Camp Dresser & McKee

July 7, 1995

Re: Response to Comments - Buncombe County MSWLF Landfill
Design Hydrogeologic Report

GRAIN SIZE DISTRIBUTION TEST REPORT

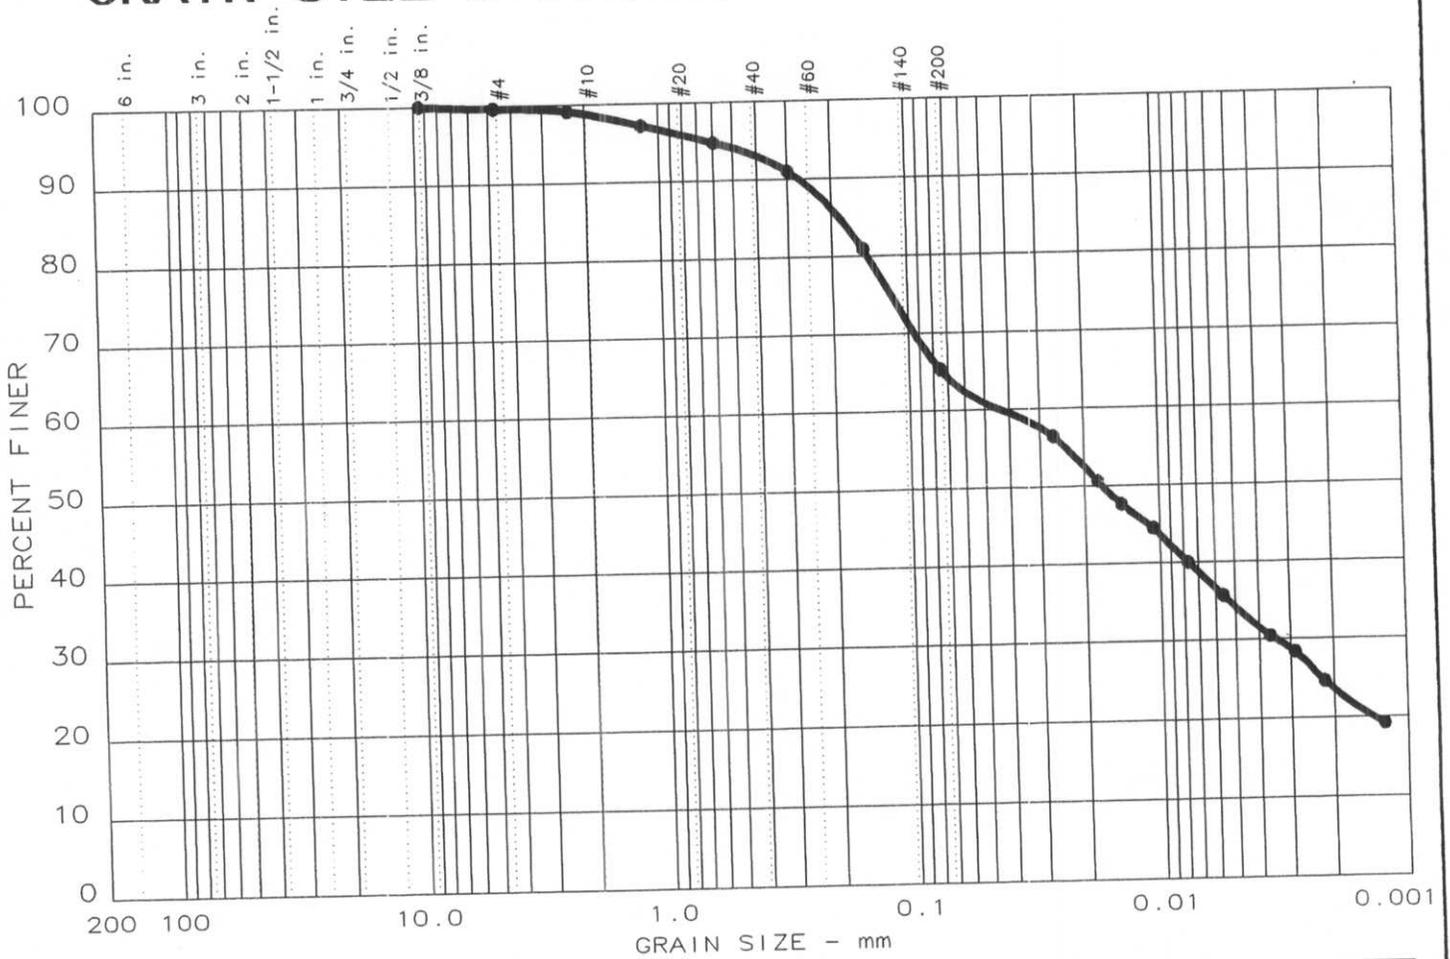
Appendix F, Laboratory Test Results: Since the liquid limit for B-313, bag 2 (20' - 30') is greater than 50, the USCS classification should be MH rather than CL.

- (4) Appendix F, Lab Tests Results, B-313, bag 2: The USCS classification for this sample is MH. We have attached a modified soil description of this sample.

Figure No. 3-2
 TYPE II GROUNDWATER
 MONITORING WELL

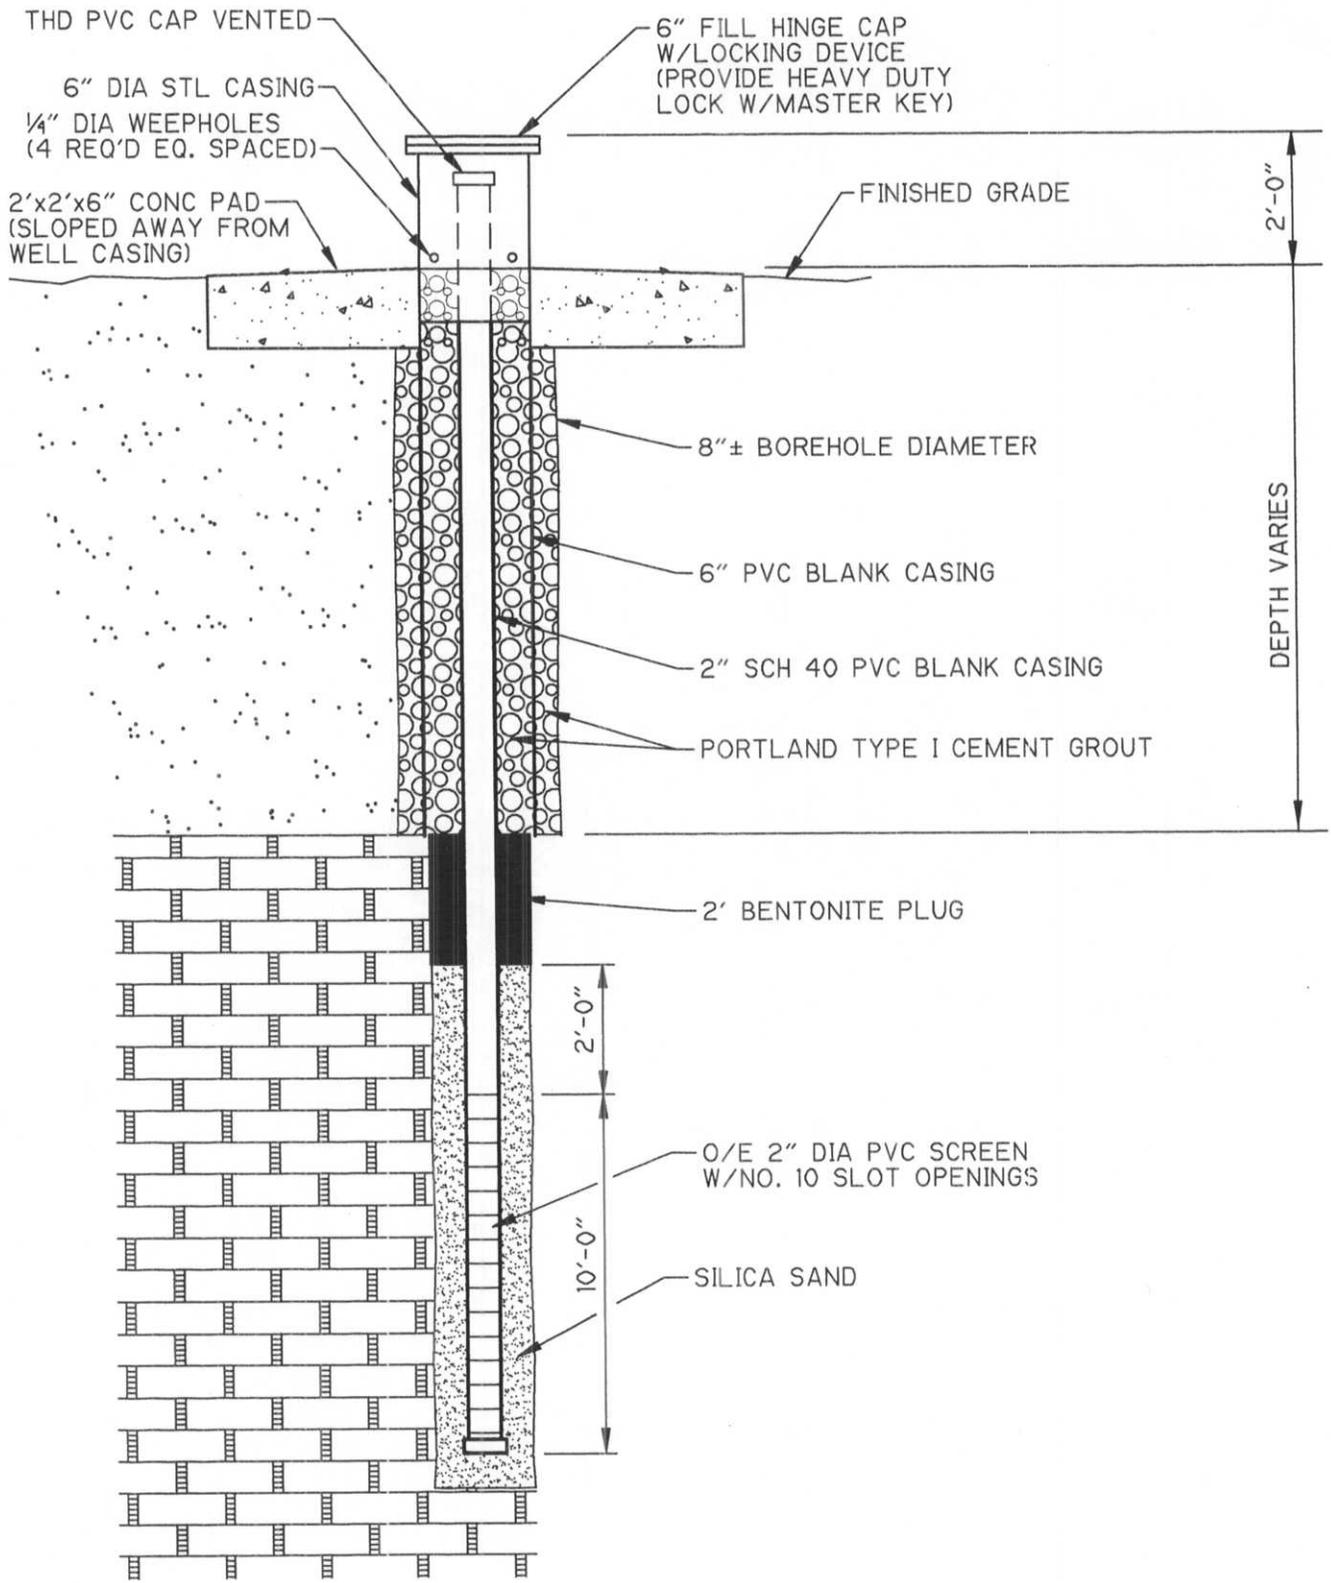
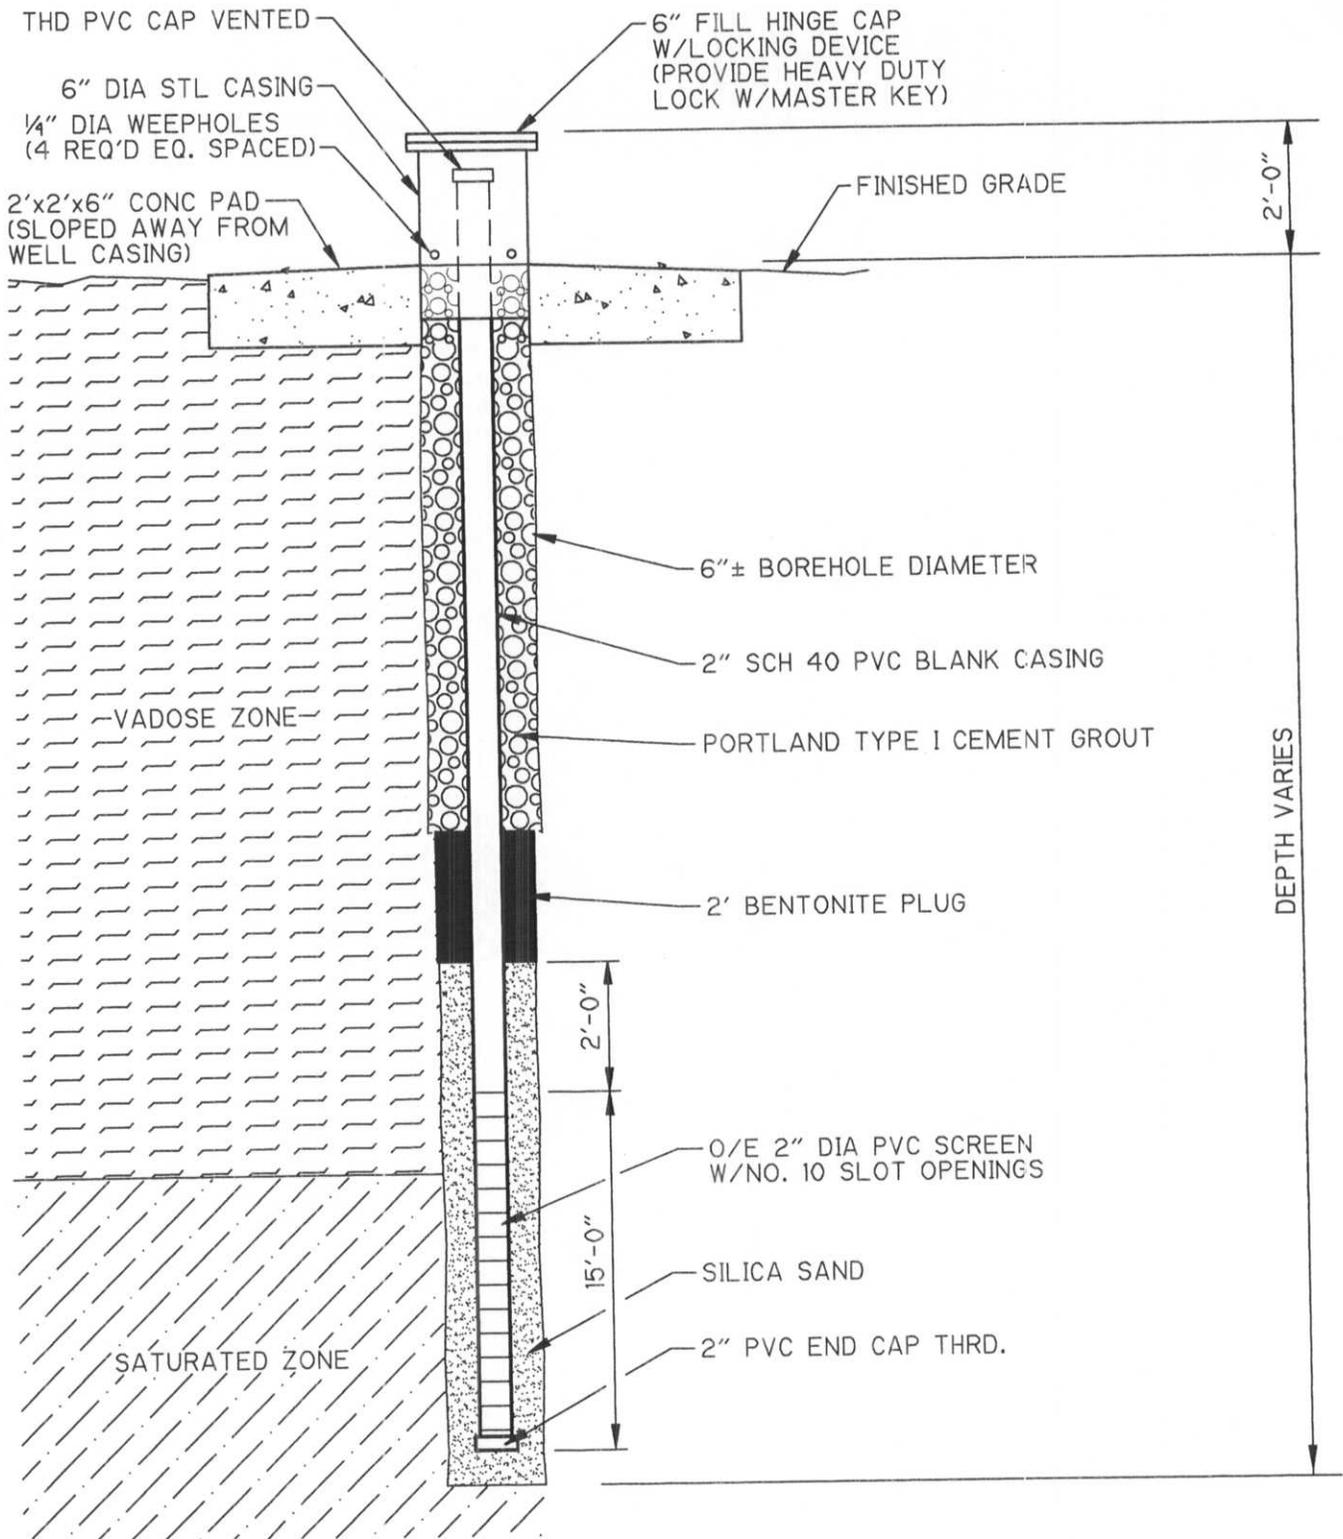
- **Figure 3-2. The grout in the annular space of the monitoring well should come up to the ground surface. The top of the concrete slab should slope to shed water away from the well and should be thick enough to firmly anchor the outer well casing and protect the well from frost damage.**

Figure 3-2 has been revised to reflect these changes and is included in Appendix E. Six inches of concrete shown on the schematic is sufficient to both anchor the casing and protect the well from frost damage.
